# SSCI assignment for MACsec XPN Cipher Suites

Mick Seaman

*Background for an IEEE 802.1X Maintenance Request and a proposed response/change.  
Updated following review of the prior version and discussion at the July 2016 meeting.*

23 **Figure 11-9—Live Peer List and Potential Peer List parameter sets**

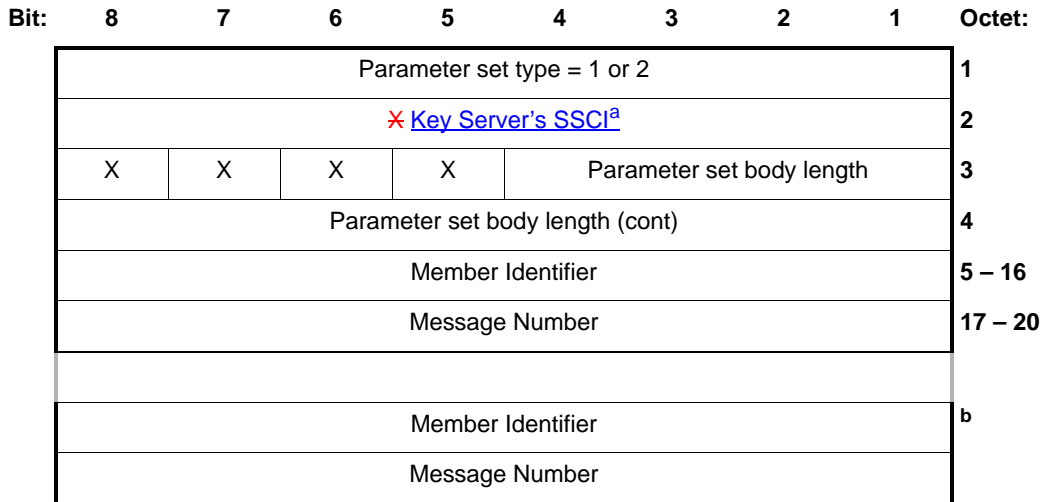
1 *Change Figure 11-9 as follows:*

24 <sup>a</sup>[The Key Server's transmit SA's SSCI is encoded in MKPDUs containing a Distributed SAK parameter set for use with an XPN Cipher Suite, otherwise 0 is encoded.](#)
